Access Compliance Report Public Rights-of-Way (Curb Ramps)

Main Street: SIENNA_PKWY		Cross Street: N_SELLAS_RD		Location:	E
ADA ID: RPRK211109125037	Ramp Type: Type 1 - Perpendicular	Initial Pass/Fail: Fail	Overall Compliance: No	Severity Score:	15

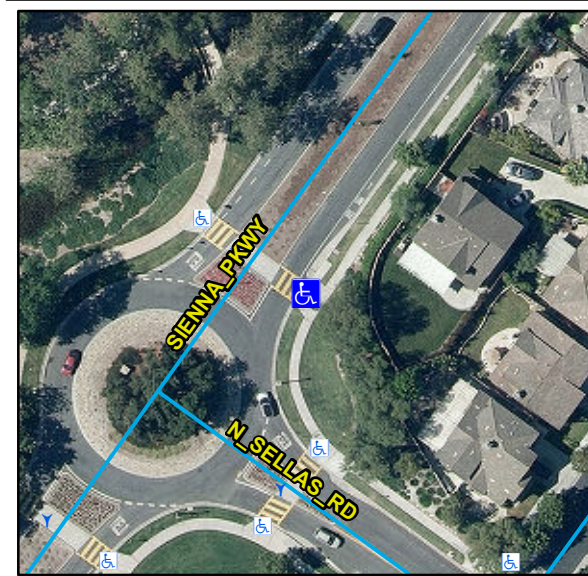
R304.2.2, R204.3, STD 1115

Remove & Replace Entire Ramp.
